Official Transcript of Proceedings
NUCLEAR REGULATORY COMMISSION

Title: Advisory Committee on Reactor Safeguards
Plant License Renewal Subcommittee

Date: Wednesday, January 12, 2011

14 This Subcommittee will review the license
15 renewal application for the Crystal River Unit 3
16 Nuclear Generating Plant and the associated Safety
17 Evaluation Report with open and confirmatory items.

SGR OPENING SEQUENCE & IDENTIFICATION OF DELAMINATION

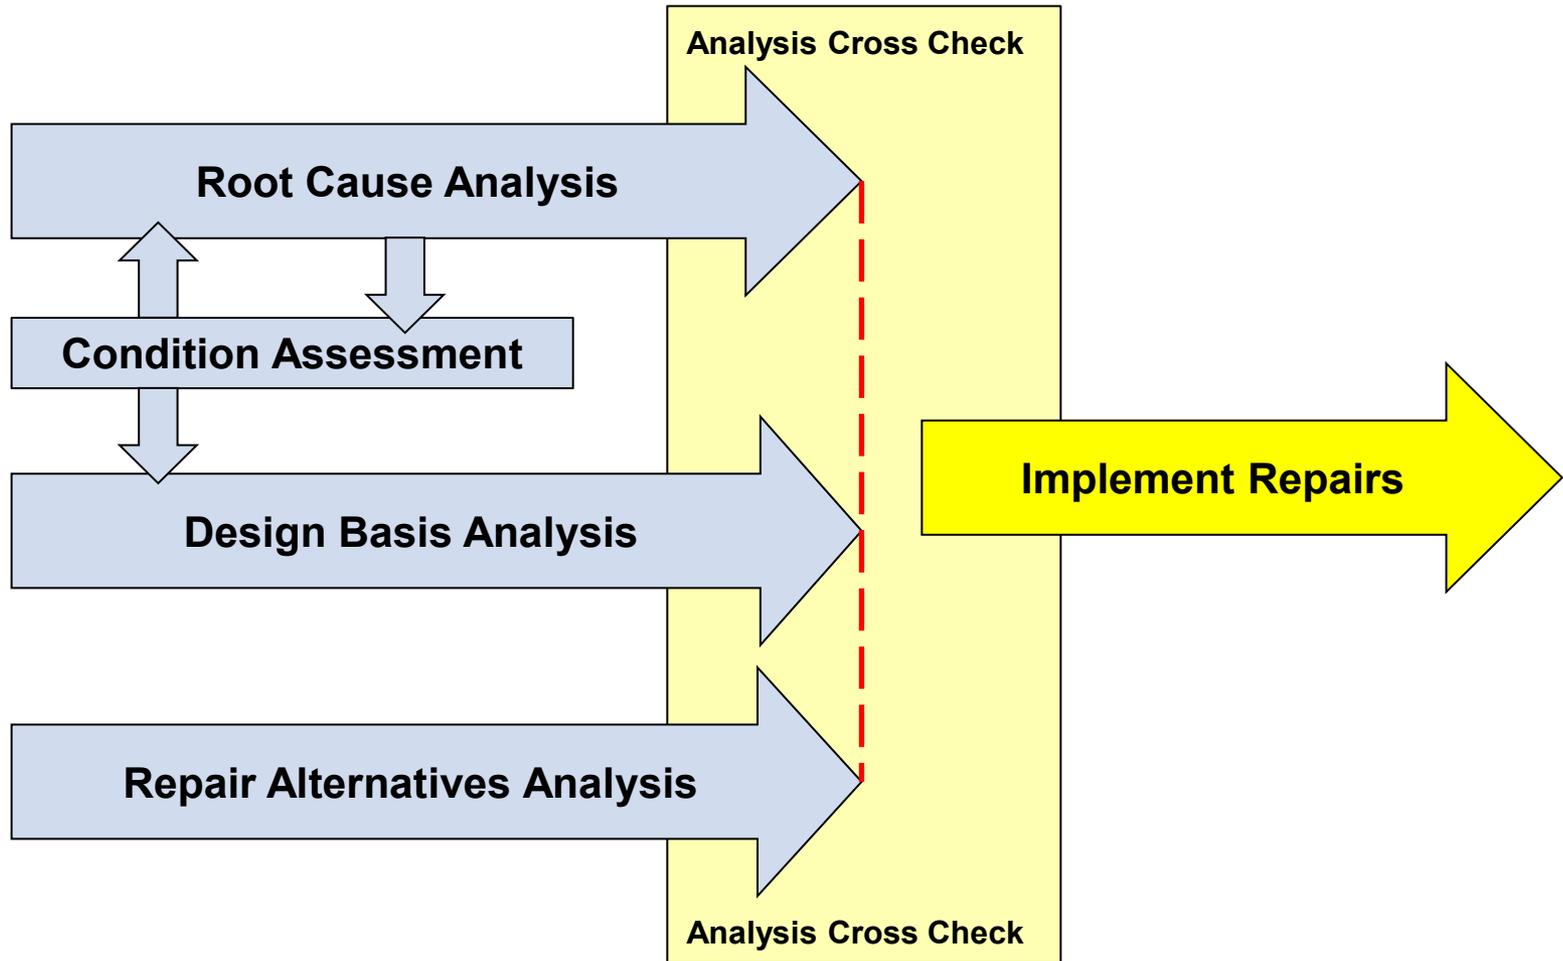
4 This graphic does depict the tendon sleeve
5 so as you can see these are horizontal tendons which
6 run in pairs and then you can see a little deeper in
7 on the inside plane of those is where the vertical
8 tendons run.

9 I'd also like to point out, note that
10 there is a complete lack of reinforcement inside the
11 plane of the tendons. There is no structural rebar in
12 that plane inside of the tendons.

13 There are a set of outer map rebar, number
14 8 bars that were part of the original design, mostly
15 just to resist thermal cracking, though they're small
16 bars, number 8s and that was just on the outside plane
17 beyond the tendons.

18 The delamination is depicted there. It is
19 the red line. You can see it and it is run
20 consistently in the plane of the horizontal hoop
21 tendon, so it's nominally about 9 to 10 inches deep
22 from the outside of containment.
